No. 93-2

A. VAPOR SEPARATOR TANK (VST) RECALL
B. ELECTRIC CONTROL MODULE (ECM) RECALL

MCM 502 EFI Stern Drive Engines
Serial Number: 0D830000-0F013999

72804

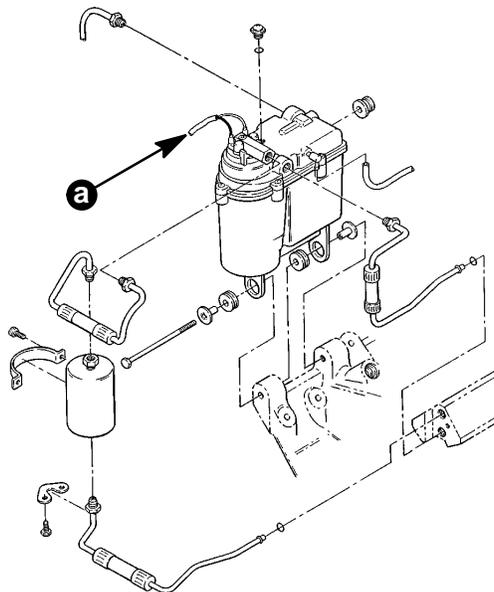
We have had a few floats, in the tank, stick because of a lack of clearance between the float and float mount. The engine ran out of fuel (stuck closed) or fouled #8 spark plug (stuck open).

DO NOT replace float or try to modify it so it won't stick. Order a replacement Vapor Separator Tank complete. A yellow dot on the VST electrical harness connector indicates that the VST has been changed already.

(1) 805415A2 Vapor Separator Tank (VST)

a - Yellow Dot

72801

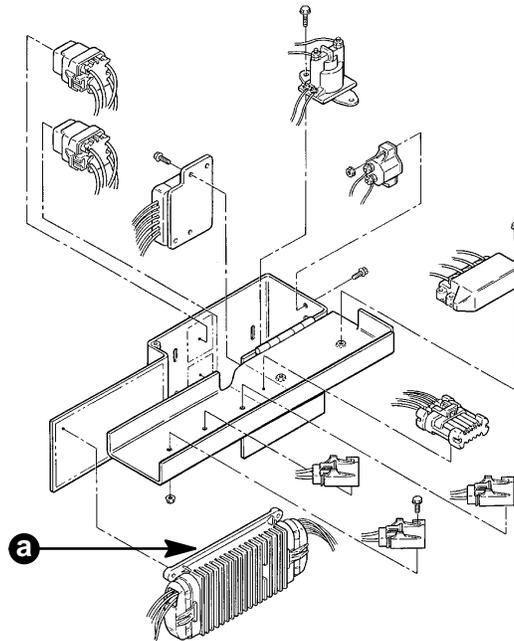
Certain Audio Warning Horns interfere with the operation of the ECM when the horn sounds. After starting the engine, idle RPM would go up and down. The interference from the horn would not let the ECM control engine idle RPM.

Order a new Electronic Control Module. If ECM has the number 9550 on it, it has already been changed.

(1) 805221T Electronic Control Module (ECM)

a - #9550 Do Not Change, #9536 Change
